LANDSCAPE DESIGN MODIFICATIONS

Martha's Vineyard Museum
 151 Lagoon Pond Road, Vineyard Haven, MA
 Oudens Eilo Architecture, LLC
 151 Lagoon Pond Road, Vineyard Haven, MA 02518
 T. 617.422.0800 F. 617.422.0805

Sheet Title:
PLANTING PLAN

Sheet No.:
L 5.1

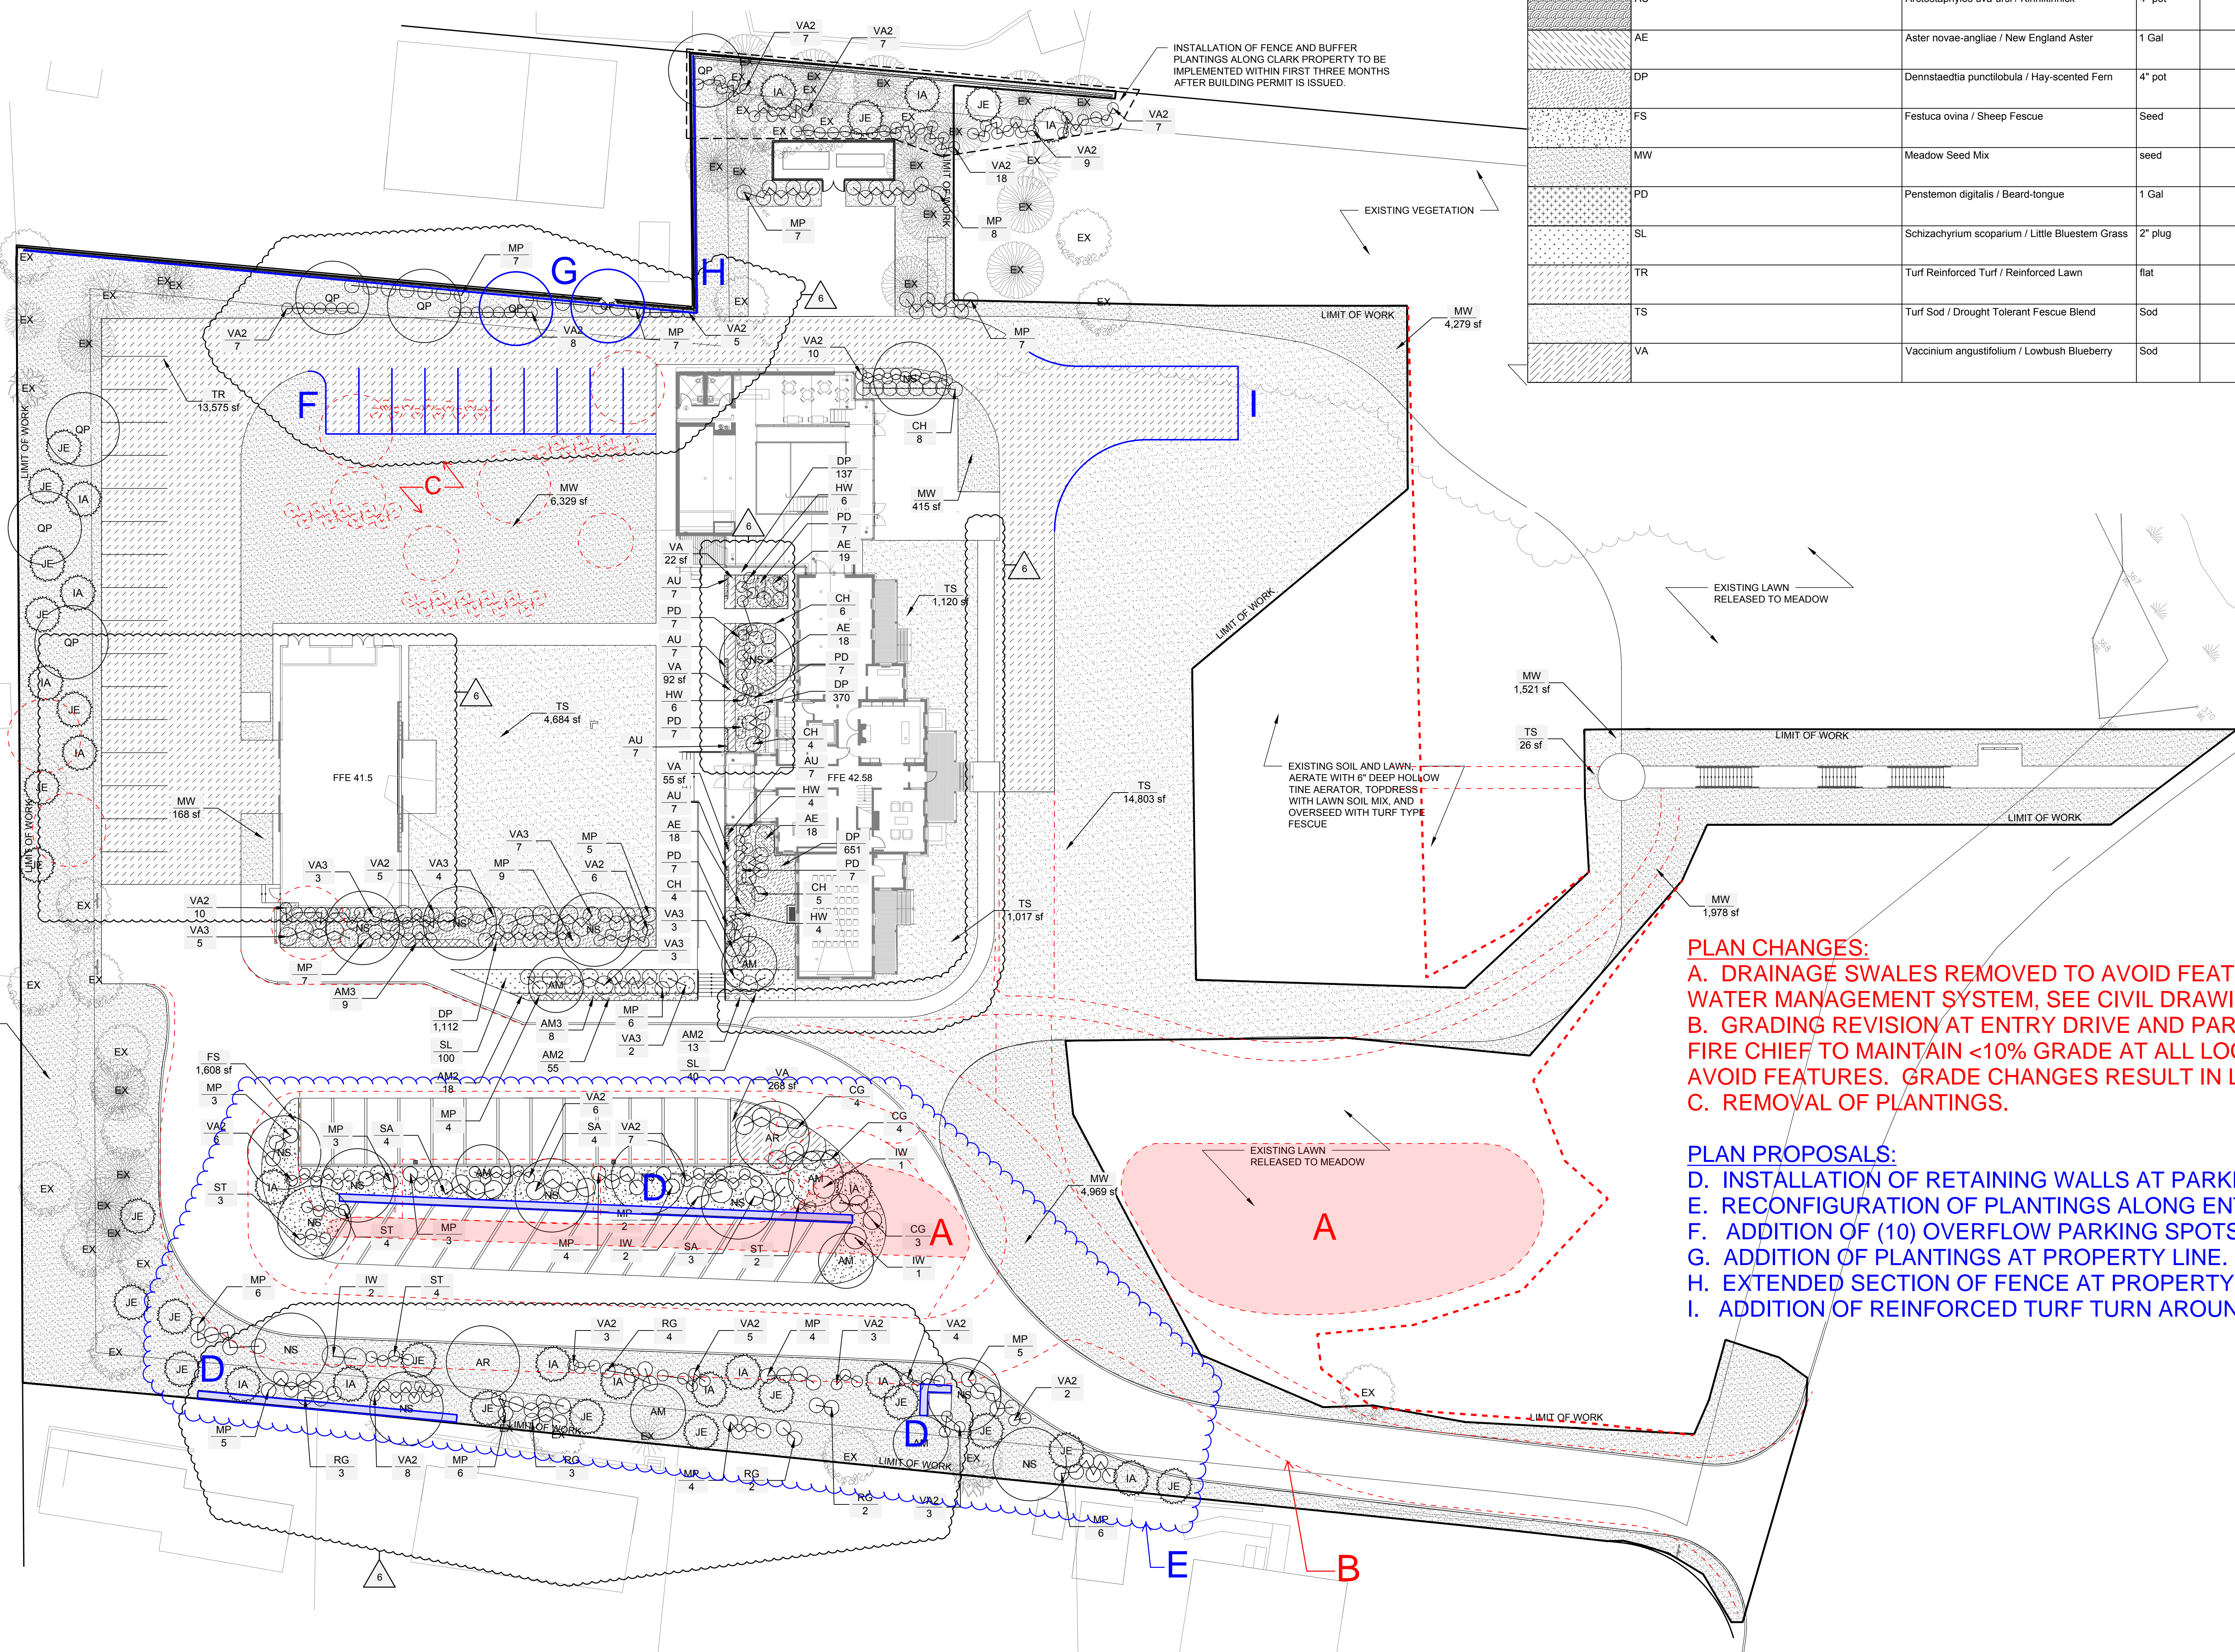
- A. DRAINAGE SWALES REMOVED TO AVOID FEATURES. TO BE REPLACED WITH NEW STORM WATER MANAGEMENT SYSTEM, SEE CIVIL DRAWING C.2.
- B. GRADING REVISION AT ENTRY DRIVE AND PARKING LOT TO ACCOMMODATE REQUEST FROM FIRE CHIEF TO MAINTAIN <10% GRADE AT ALL LOCATIONS FOR EMERGENCY VEHICLES AND TO AVOID FEATURES. GRADE CHANGES RESULT IN LOSS OF (4) PARKING SPOTS.
- C. REMOVAL OF PLANTINGS.

- D. INSTALLATION OF RETAINING WALLS AT PARKING LOT TO ACCOMMODATE GRADING CHANGES.
- E. RECONFIGURATION OF PLANTINGS ALONG ENTRY DRIVE AND PARKING LOT.
- F. ADDITION OF (10) OVERFLOW PARKING SPOTS ON REINFORCED TURF.
- G. ADDITION OF PLANTINGS AT PROPERTY LINE.
- H. EXTENDED SECTION OF FENCE AT PROPERTY LINE REQUESTED BY NEIGHBOR
- I. ADDITION OF REINFORCED TURF TURN AROUND FOR EMERGENCY VEHICLES
